STATE OF MAINE  
DEPARTMENT OF TRANSPORTATION  
16 STATE HOUSE STATION  
AUGUSTA, MAINE 04333-0016

February 2, 2023  
Subject: Acadia Gateway  
State WIN: 017163.03  
Location: **Trenton**  
**Amendment No. 7**

Make the following changes to the bid documents:

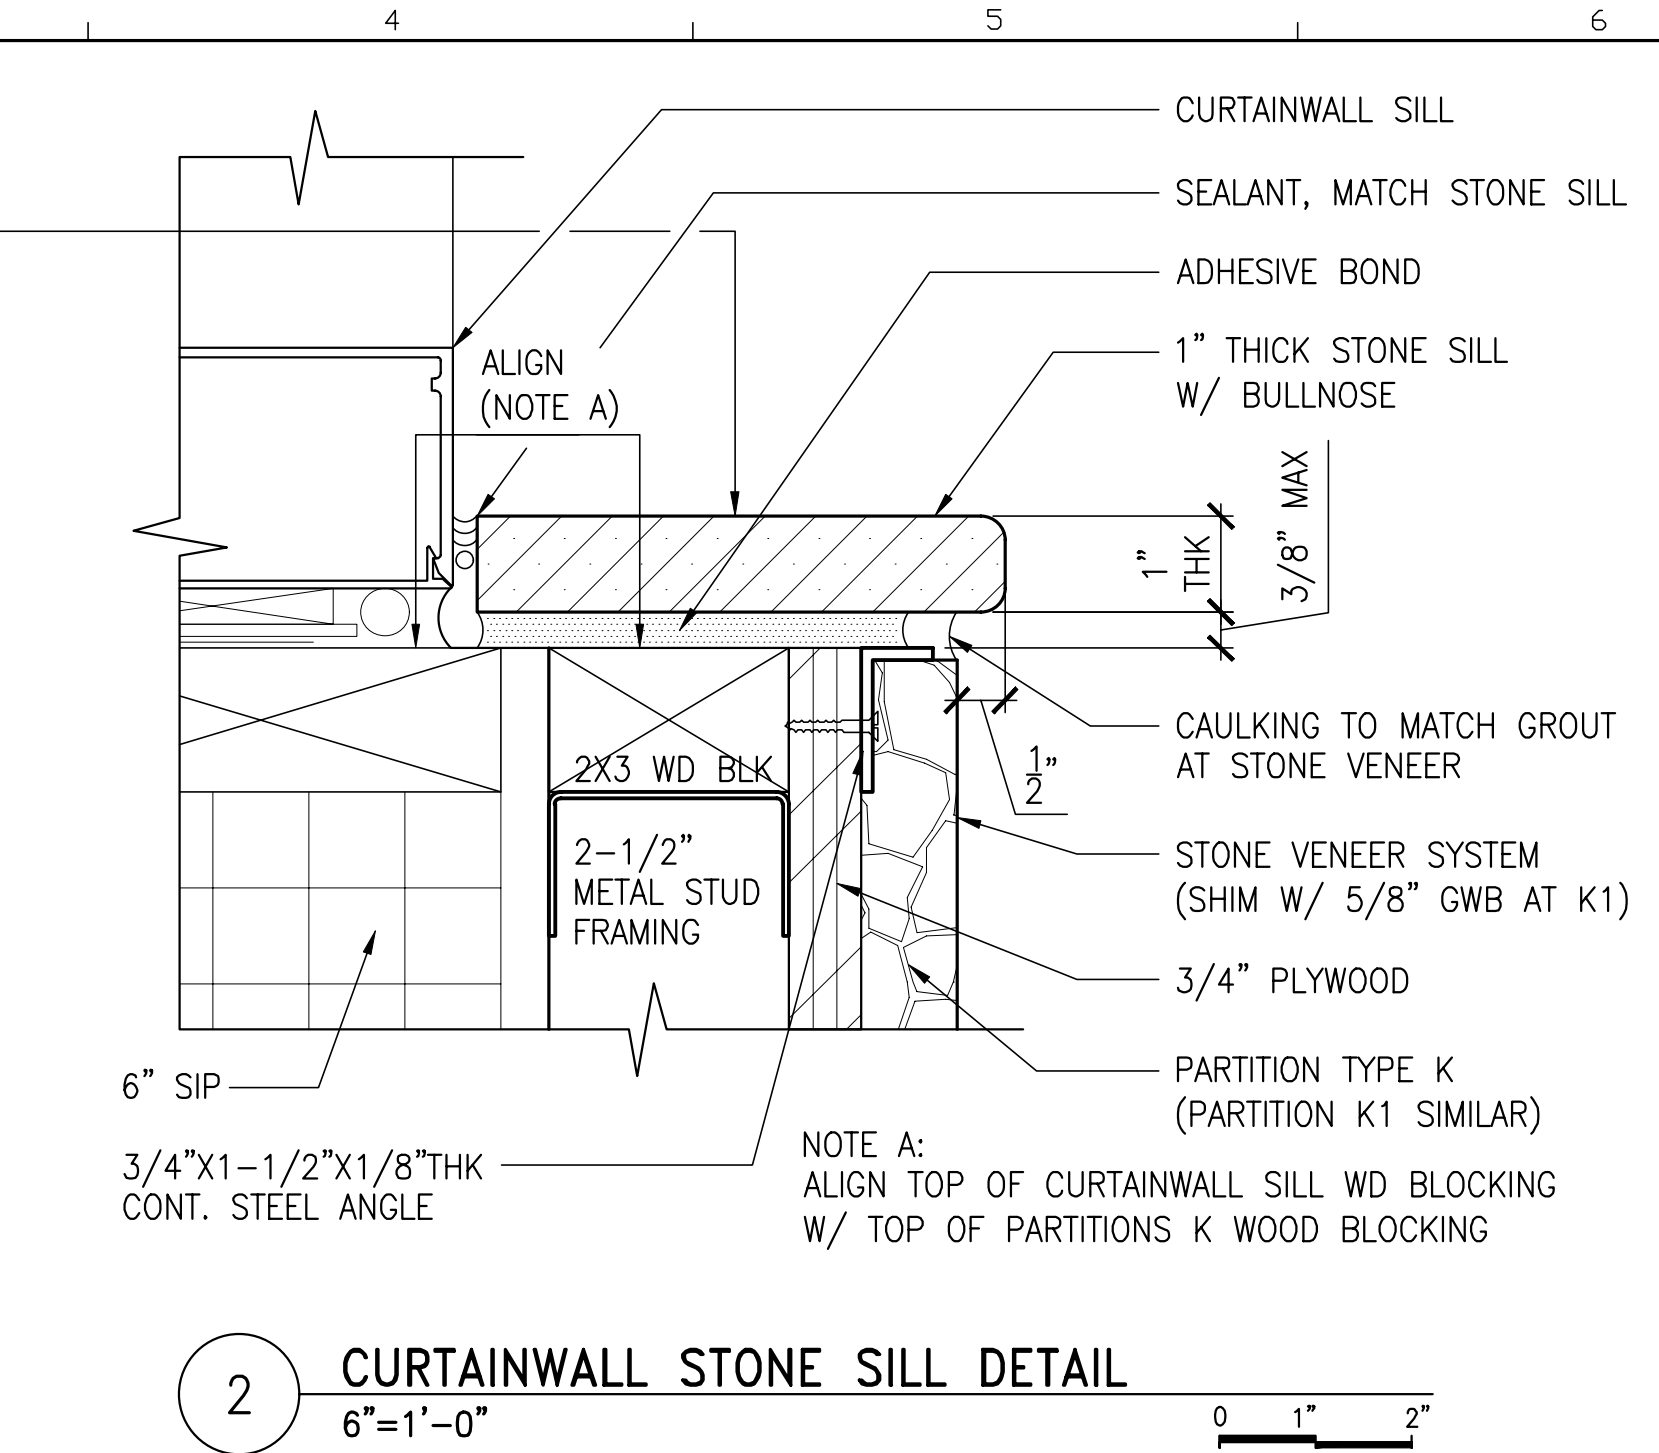
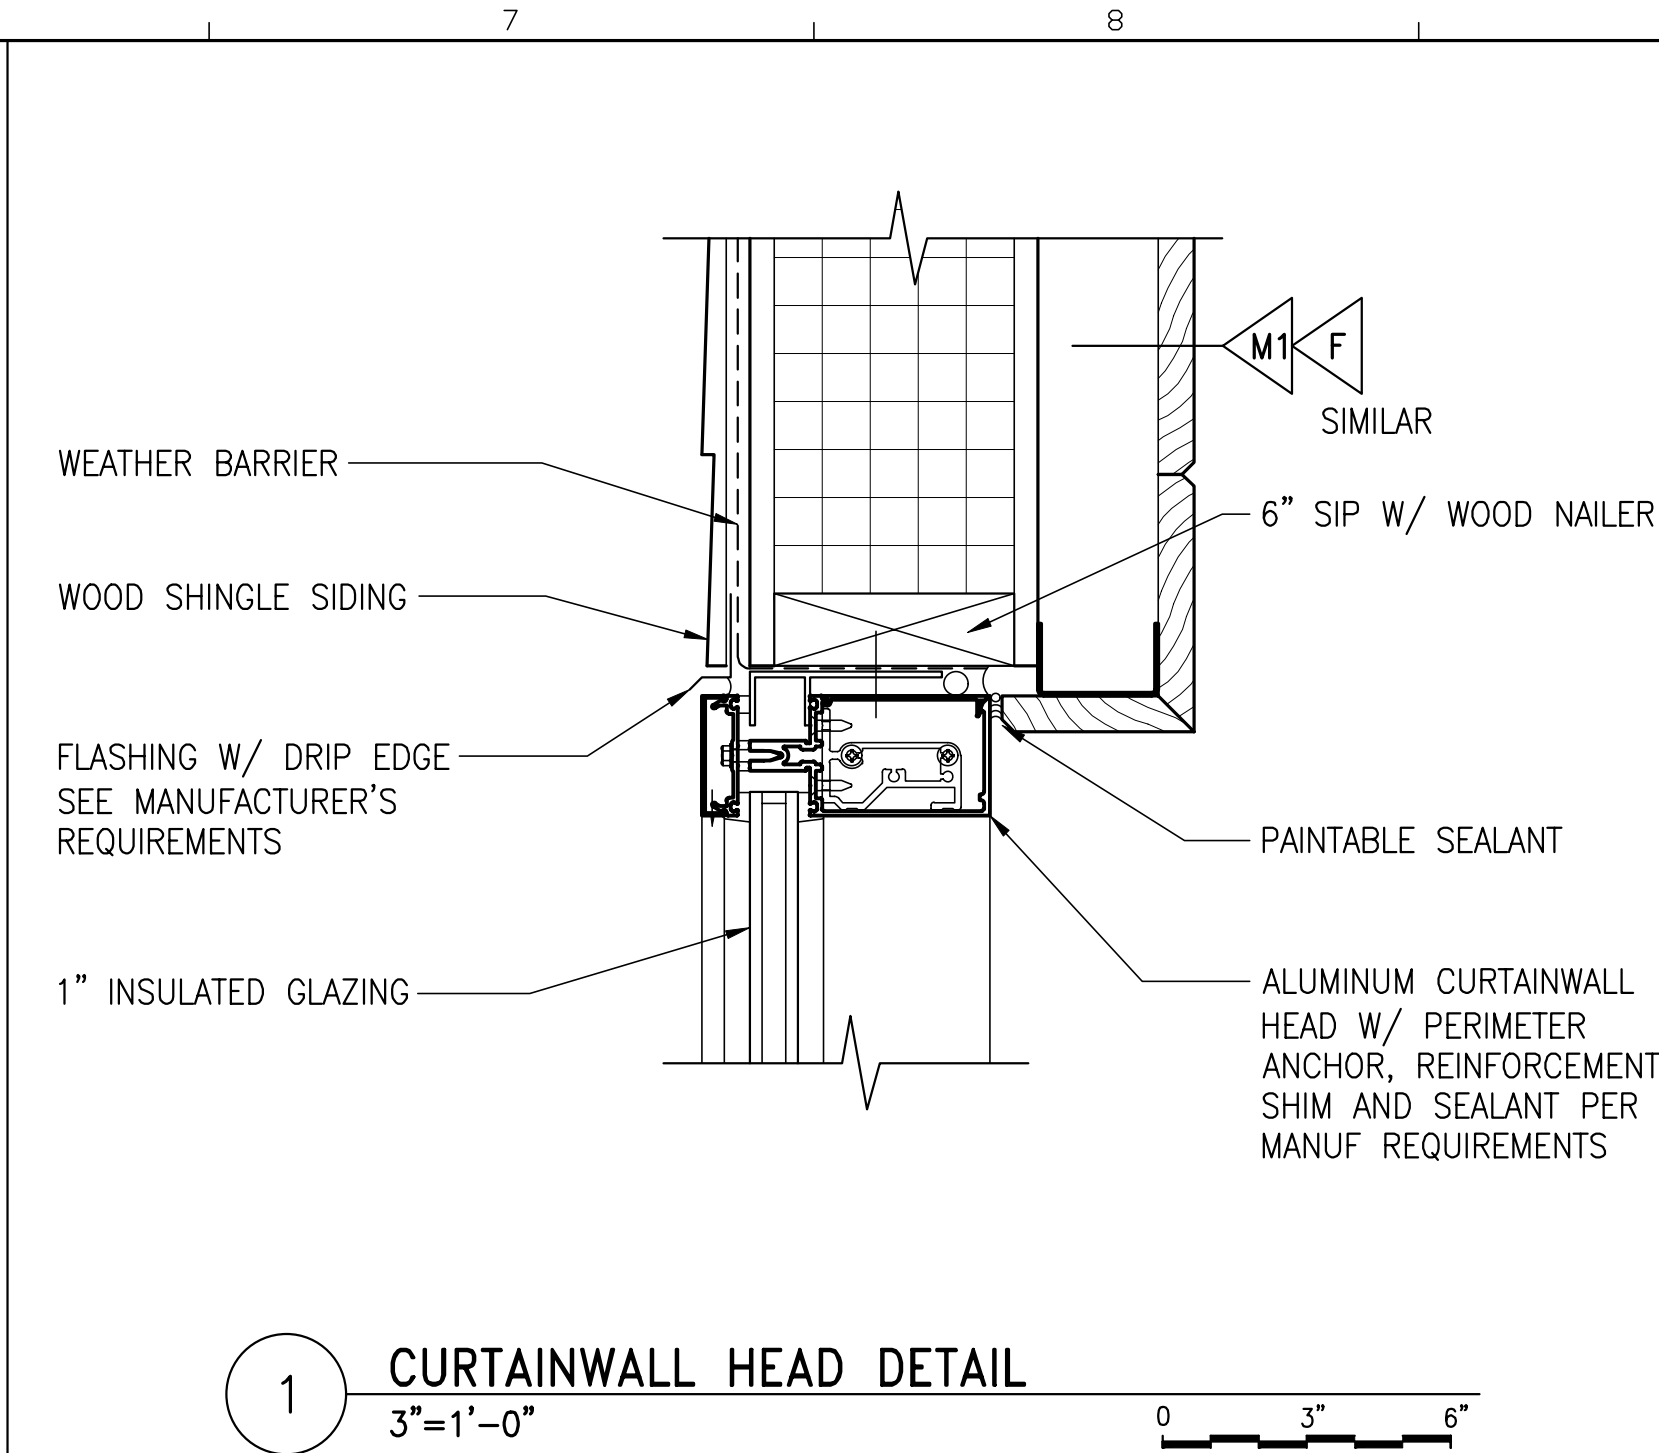
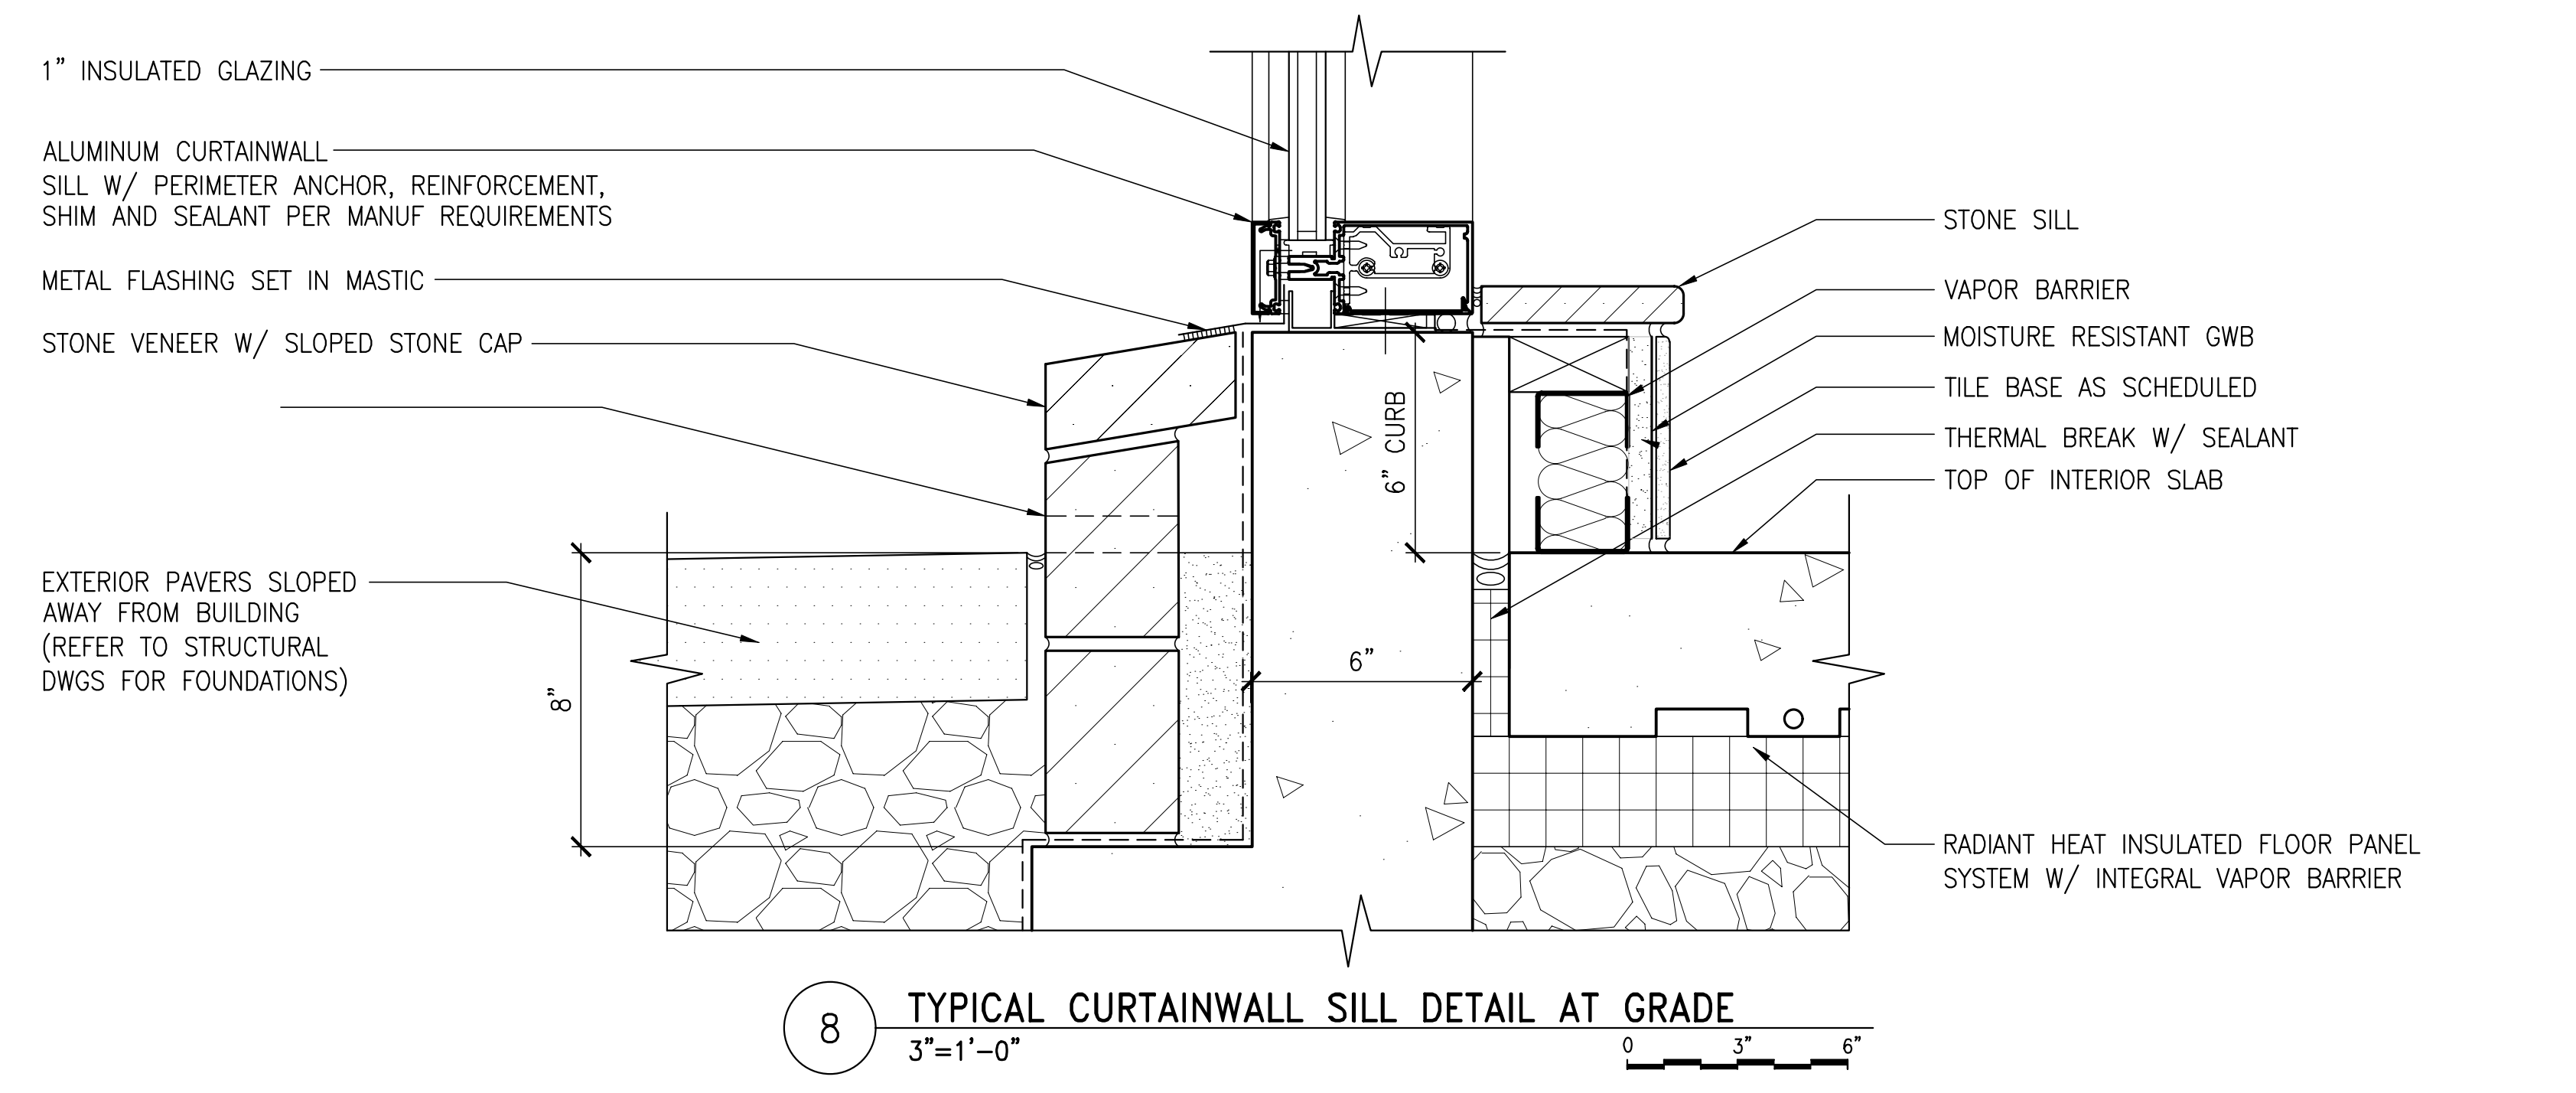
**Question:** Drawing A816 detail 2,3,4 & 8 indicate a stone interior sill. It is graphically shown smooth with a bullnose. The specified stone is rough. Please confirm the sill material and its finish

**Question:** Drawing a816 detail 2,3,4, & 8 indicate a stone interior sill. It is graphically shown smooth with a bull nose. The specified stone is rough. Please confirm the sill material and its finish

**Response:** This information was provided in Amendment #6.

**Response:** This information was provided in Amendment #6.
